## Remediation & Redevelopment Continuing Obligation Review

BRRTS ID No. <u>02-68-245535</u>					JIII 4400-232 (IX 07/22)	rage 1 019		
Reviewer: Paul Grittner & Rob Hoverman			Regi	on: SE	Review Date:	08/24/2023		
Site Name: Distinctive Cleaners								
follow up	; ** denote	e RP/pro		p. If auditing a VI	PLE site, use the	<u>242.pdf</u> . Steps with a applicable LUST or E Idressed.		
File Revie								
		and the	file if needed, to ider	ntify the File Revie	w information:			
Site Addre					City	ZIP Code		
			W North Ave)		Brookfield		53045

Title: East end of parking lot

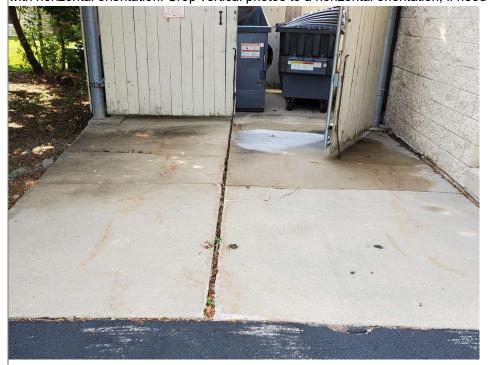
Has the land use changed such that there are either health or safety issues?  No
Yes – Describe any follow up needed:
Notes:
Concrete pads are starting to separate, gravel behind dumpster areas starting to get thin. Both areas may need maintenance soon.
COMPLIANCE AND FOLLOW-UP SUMMARY:  5. Identify compliance and any follow up needed.  Is the site in compliance with the continuing obligations/closure approval document?
○ Yes
<ul> <li>No - Describe what's not in compliance and the reasons for noncompliance:</li> <li>Maintenance plans not kept on-site. Inspections of cap or vapor mitigation system not conducted - or were not recorded. New owners were not notified of continuing obligations on the property.</li> </ul>
(May depend on extent of non-compliance, non-maintenance of remedy or changed ownership or conditions. If case is out of compliance, it should be prioritized by the region, for new casework or enforcement, as needed.)  Has the maintenance agreement required at closure been followed?  Yes
